UNITED STATES PATENT AND TRADEMARK OFFICE

APPLICATION NO.	FILING DATE	FIRST NAMED INVENTOR	ATTORNEY DOCKET NO.	CONFIRMATION NO.
10/780,169	02/17/2004	David J. Waller	200311815-1	1264
22879	7590	10/02/2008	EXAMINER	
HEWLETT PACKARD COMPANY			UHLENHAKE, JASON S	
P O BOX 272400, 3404 E. HARMONY ROAD			ART UNIT	PAPER NUMBER
INTELLECTUAL PROPERTY ADMINISTRATION			2853	
FORT COLLINS, CO 80527-2400				
NOTIFICATION DATE		DELIVERY MODE		
10/02/2008		ELECTRONIC

Office Action Summary	Application No.	Applicant(s)	
	10/780,169	WALLER ET AL.	
	Examiner	Art Unit	
	JASON S. UHLENHAKE	2853

DETAILED ACTION

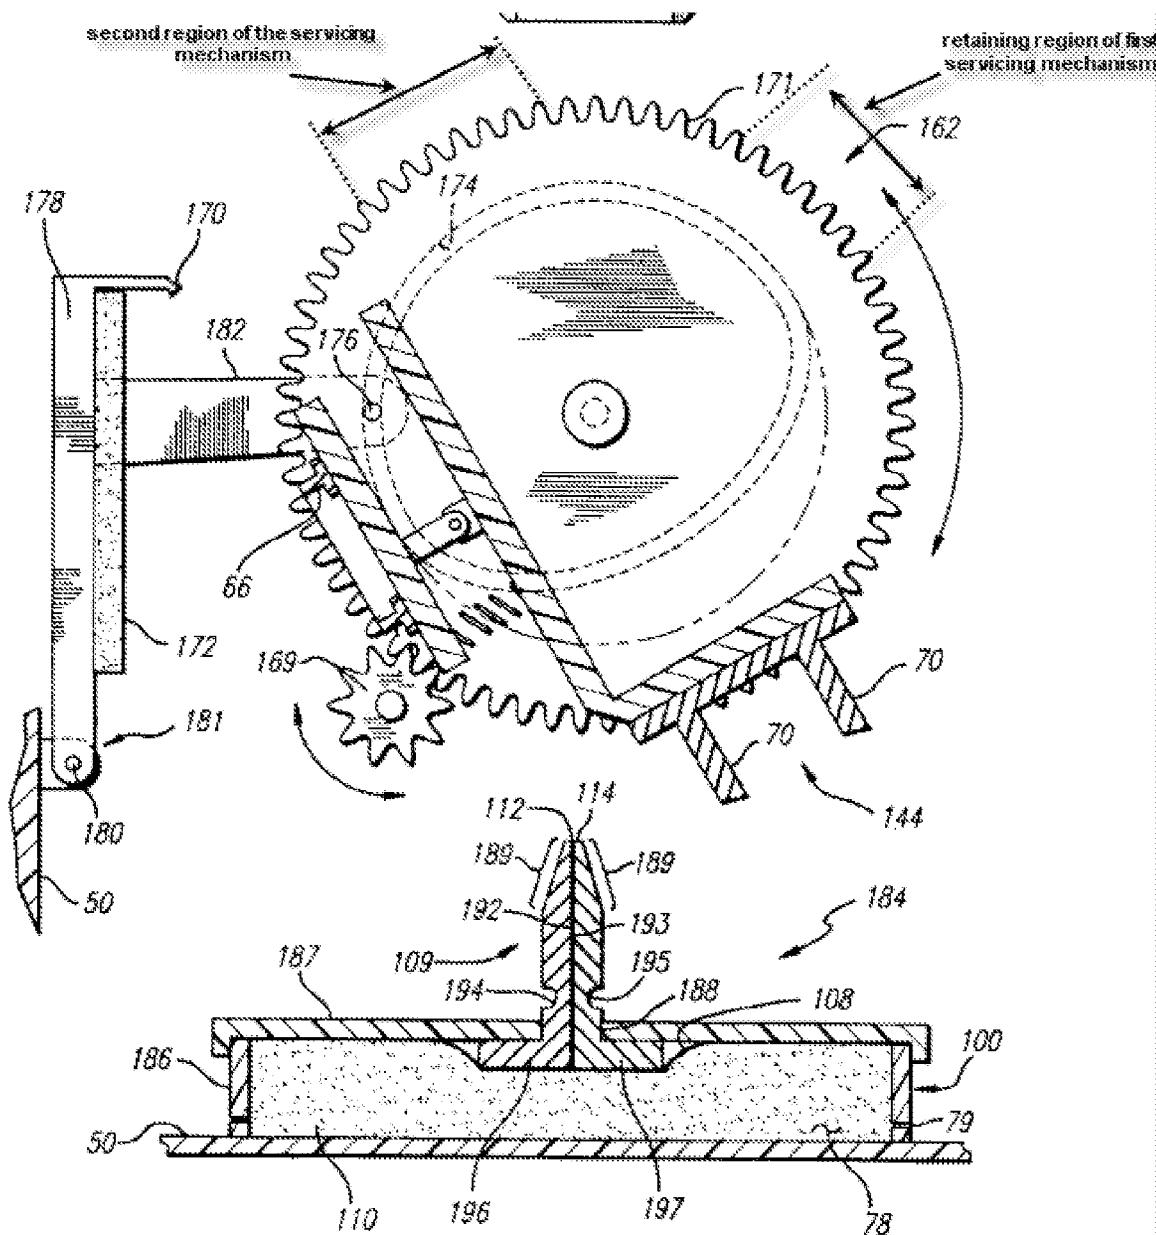
- ***regarding claim 31***, a driveshaft (82); a sled (180) including a rack (198) adapted to selectively engage the driveshaft and a retaining wall (housing structure 52) positioned to retain the driveshaft on the rack in a zone (Column 7, Lines 28-30, Lines 45-55; Column 8, Lines 11-27)

- ***regarding claim 38***, a motor (102) that drives the power shaft (Figure 4)
 - ***regarding claim 39***, a sled further includes a cap (182, 184), a wiper (186, 188) and a spittoon (68a, 68b)

Figures 4 and 5: Retaining walls

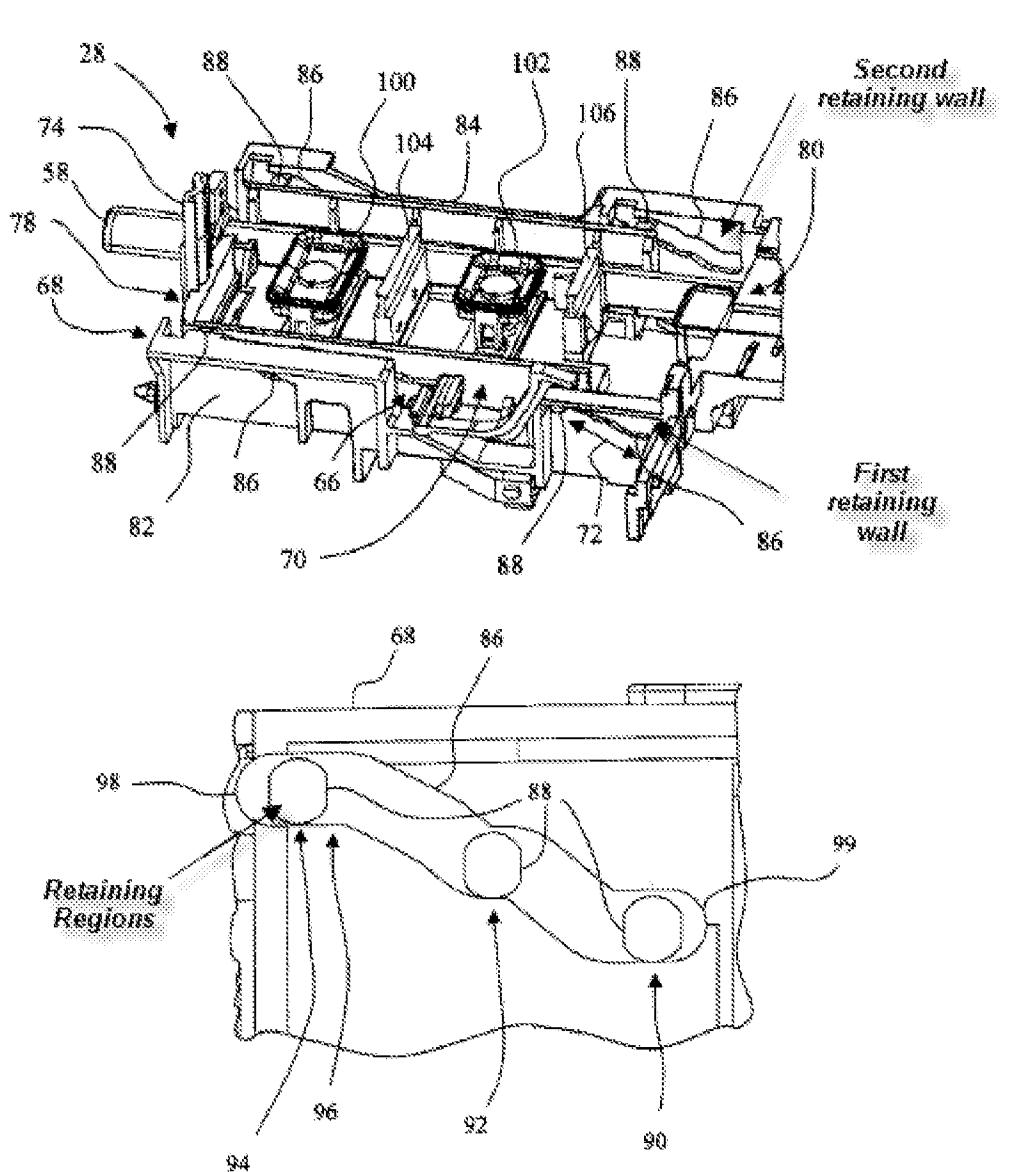
- ***regarding claim 16***, a biasing member that biases the drive structure to move from the first engaged position to the disengaged position, the first retaining wall including a retaining region that retains the drive structure in the first engaged position and against biased movement to the disengaged position when the drive structure is positioned within the retaining region (Figures 4 – 5; Paragraphs 0008; 0044 – 0045; 0050), for the purpose of guiding and securing a maintenance sled.

- ***regarding claim 17***, a biasing member that biases the drive structure to move from the first engaged position to the second engaged position, the second retaining wall including a retaining region that retains the drive structure in the first engaged position when the drive structure is positioned within the retaining region (Figures 4 – 5; Paragraphs 0008; 0044 – 0045; 0050), for the purpose of guiding and securing a maintenance sled.

- wherein the biasing member biases the shift arm to pivot from the actuated position to the non-actuated positions; a printhead carriage operable to pivot the shift arm from the non-actuated position to the actuated position by overcoming a biasing force of the biasing member (Figures 4 – 5; Paragraphs 0008; 0036; 0044 – 0045; 0050), for the purpose of guiding and securing a maintenance sled.

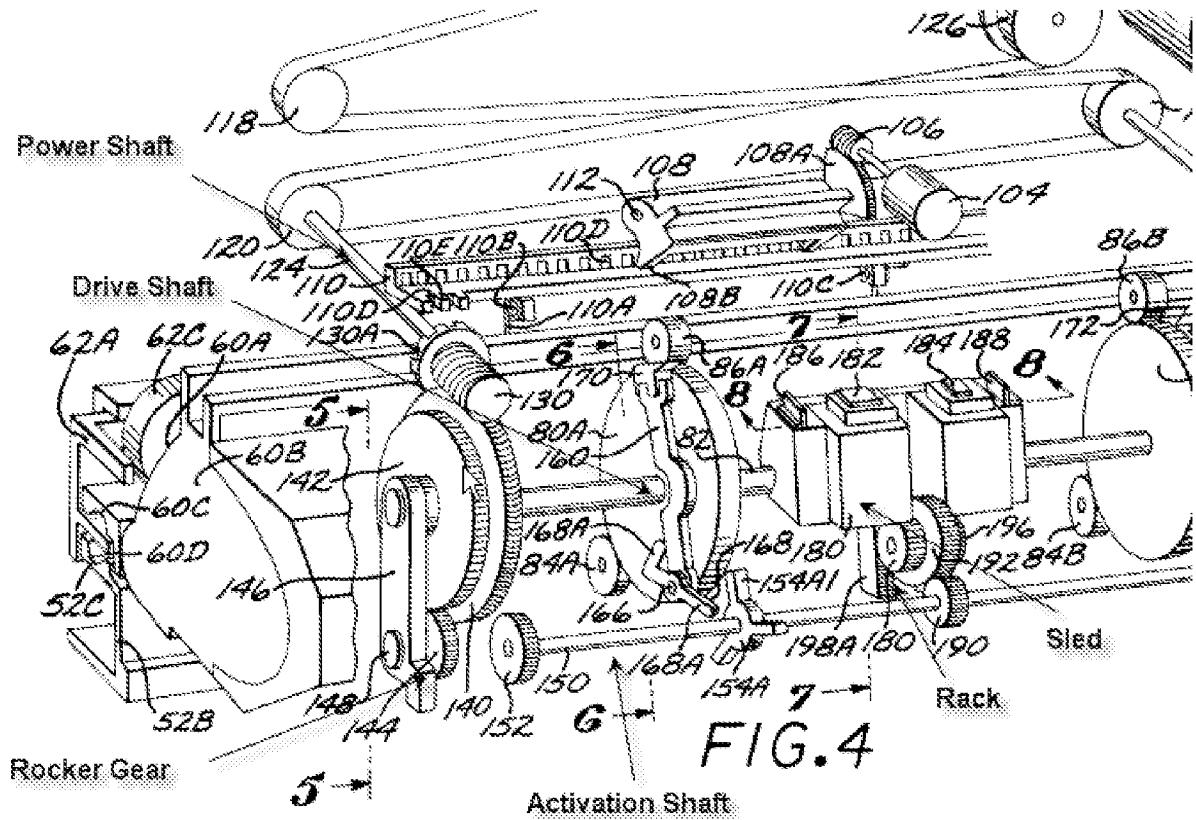
Regarding claim 13, applicant argues that Hirano does not disclose a servicing station drive structure. Hirano discloses cams 34a and 37a which moves/drives the caps (34, 37) to pivot toward the printing head (Column 5, Lines 53-59). The service station drive structure is moveable between a disengaged position, a first engaged position (when the cap 37 is moved by the cam and is engaged with black head 11), and a second engaged position (when a cap 34 is moved by the cam and is engaged with color heads 20-22), the drive structure in the first engaged position engaging the

first engagement structure and the drive structure in the second engaged position engaging the second engagement structure (Figures 1, 3)
